☑ CTL Provisional DECISION SHEET (PDSH)

Standard(s) (incl. year)	**Subclause(s)**	**Tracking No.**
IEC 60598-1:2020	7.2	2275
Category		
LITE		
Subject	**Keywords**	**Provided to**
Earthing connection	Earthing connection	ETF 5

Picture 1	Picture 2

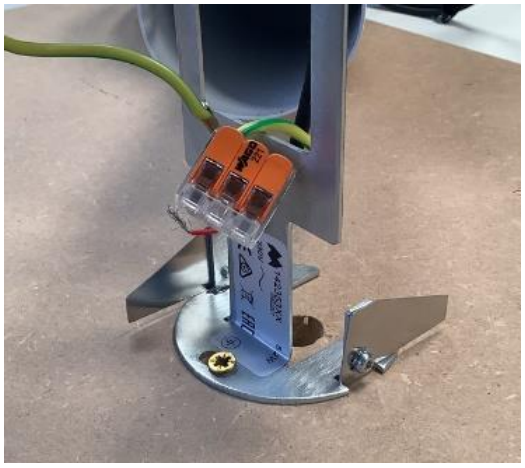
The earthing connection for the metal bar which is fixed to the ceiling is made by two screws on each side. The force of the screws will make the connection.

Can this connection be considered as permanent and reliable?

Or is an additional connection needed by screws or other means which are more reliable?

For a class I luminaire which is fixed to the ceiling a cover is used to protect the parts with basic insulation. This cover is not fixed by screws but by a couple of springs (minimum 2) in Picture 1; the springs scratch into the metal of the cover. In Picture 2 they don't.

Question 1: Are springs like the two examples above considered as permanent earthing contact if the product complies with 8.2.6 and can withstand a force of 20 N perpendicular to the mount surface?

Question 2: If not, can these examples be considered as screwless terminals and be tested to §15?

These kinds of earthing connections are acceptable if clauses 7.2.1 and 7.2.3 for screw connection are fulfilled.

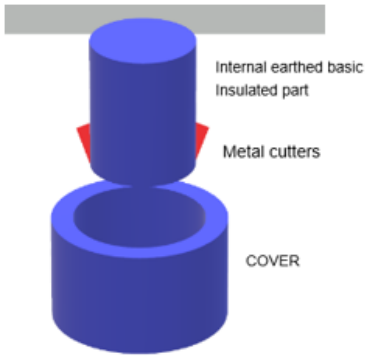
Question 3: Can fix metal cutters which are pushed into the metal part of the cover be used forpermanent earth connection if they comply with 8.2.6 (applying a test force of 20 N)? See illustration below.
